PERMIT

SEWAGE DISPOSAL SYSTEM

MARYLAND STATE DEPARTMENT OF HEALTH

SUBDIVISION Woodmark

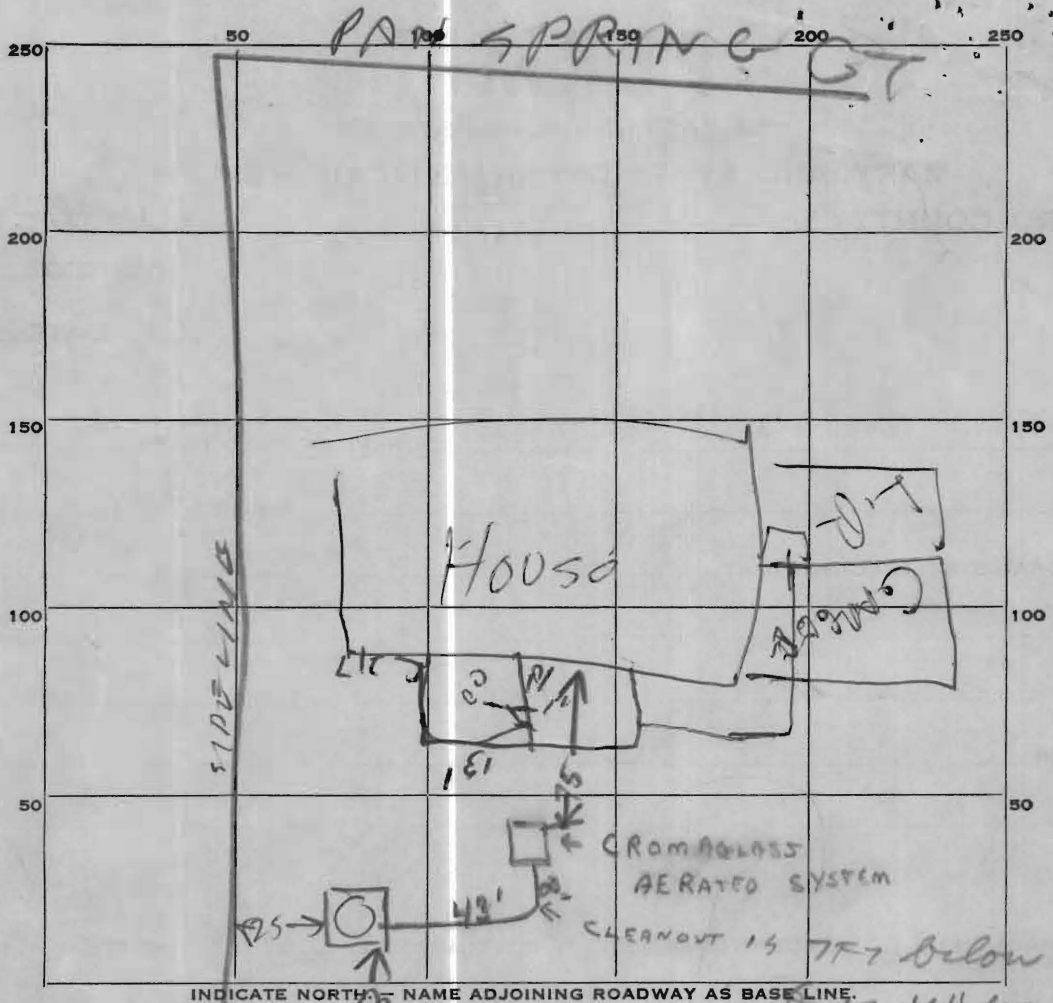
sampling port needed between septic tank & drywell
NO 11/15/73 11/15/73 sampling port not required on Mr. Jung's system

11/8/73 Aerated system checked - R.T.

11/15/73 - Dry Well Inlet is 6 FT below grade

Perimeter is 73 FT Dry Well is O.K. Hold's on

Do not know if all house sewer inspected

"Sampling Port" is nothing but a 4" cleanout

10/29/73 - OK to have dry well inlet at 6 ft and make

Wide Square Hole (17FT) with inlet no deeper than 12 FT. 17H
